# January 2017 Recommended Contracting Actions

<i>Construction Change Orders</i>		
<b>WP-42A.1/A.3, 4<sup>th</sup> Street Pump Station Change Order 09</b> <ul style="list-style-type: none"><li>Fuel level Sensors, Floodwall coping, and Trash Rack Modifications</li></ul>	ICS, Inc.	<b>\$12,506.80</b>
<b>Total Construction Change Orders</b>		<b>\$12,506.80</b>

**Change Order No.** 09

4th Street Pump Station and Gatewell - 2nd Street Floodwall South

# Series HTF Standard Three Float Sensor

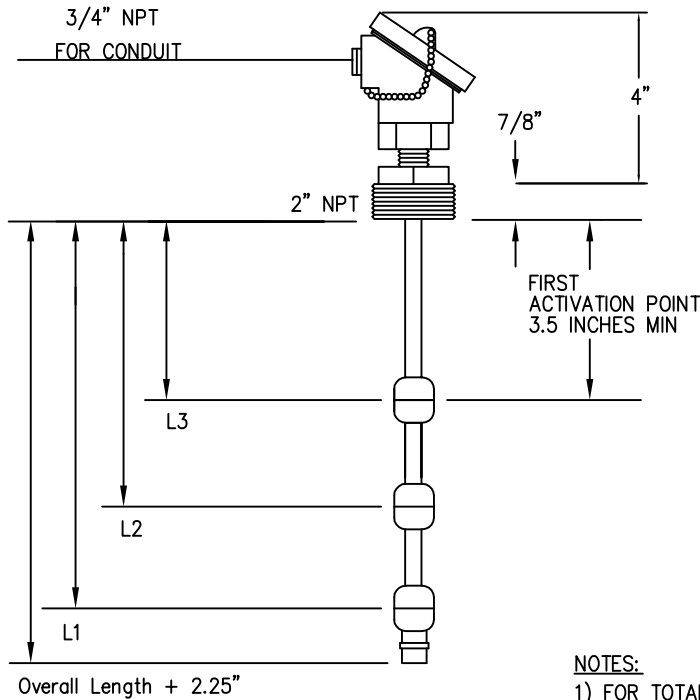
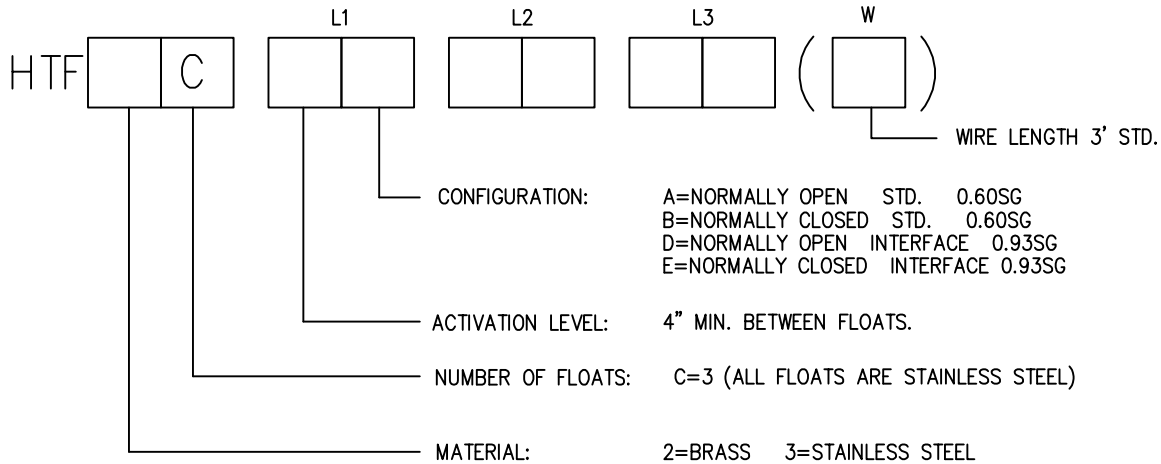
The attached costs are to add level sensors to the fuel storage tank. The added sensors will monitor the 25%, 50% and 75% fuel levels in the fuel tank.

The level sensors will be added per the attached quote from Fusion Automation OPTION A. The proposed sensor information is also attached to this quote.

**OPTION A:** HTF 3 float stem sensor

- Only measures 3 set levels
- Electronic feedback
- Labor for Install

Task: Trash Rack Adjustment

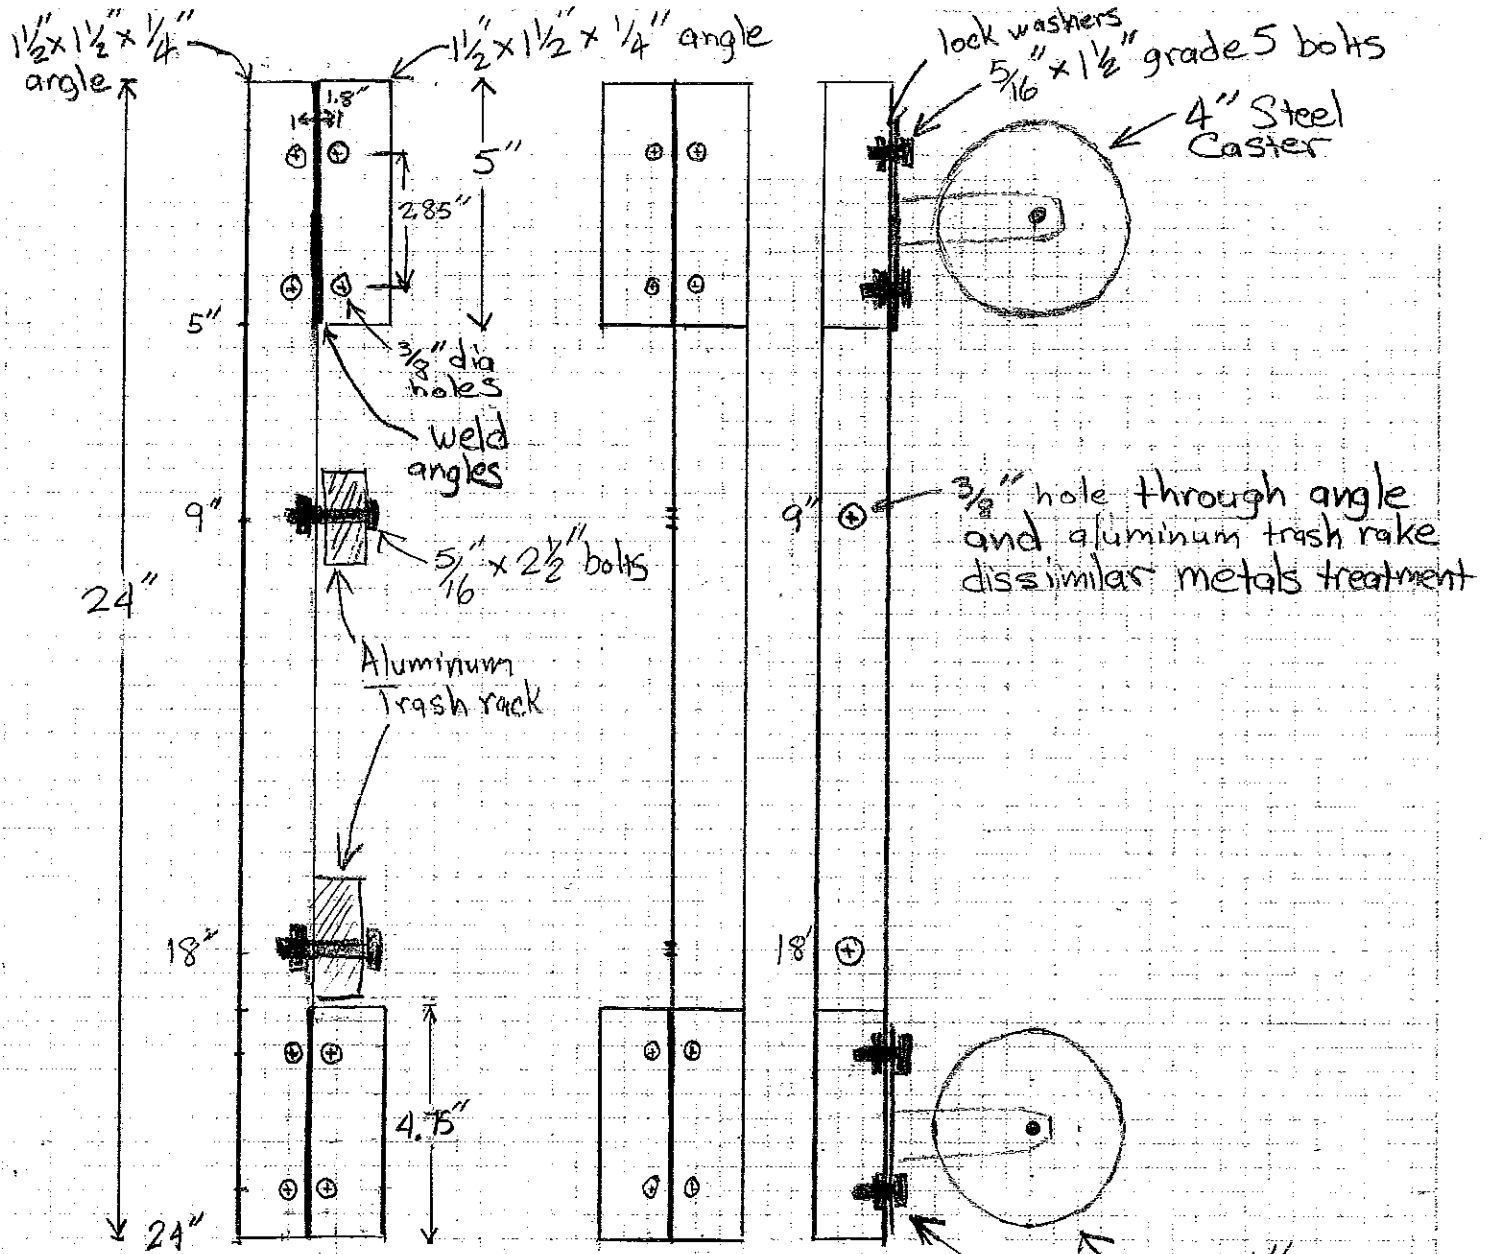
The attached cost is for a design change to the Trash Rack Rake System in the pump station. Glen Krogman with HMG requested the change so that the trash racks would operate smoother.

The trash rack rake modifications were requested by HMG to improve functionality. Glen Krogman with HMG provided a sketch dated 12-07-16 showing the changes and is the basis for our pricing. It is our understanding that the design was based on a prototype that operated in the field. This price includes materials, labor for installation, as well as labor to help Glen in the field with fitting his prototypes.

4 pieces galvanized

- 16 - 4" casters  
100018 STF-04RSC
- 64 - 5/16" grade 5
- 16 - 1 1/2" long
- 80 - 2 1/2" long bolts
- 64 - 5/16" nuts
- 80 - 5/16" lock washers

Casters are from Mac's Hardware per Glen Krogman
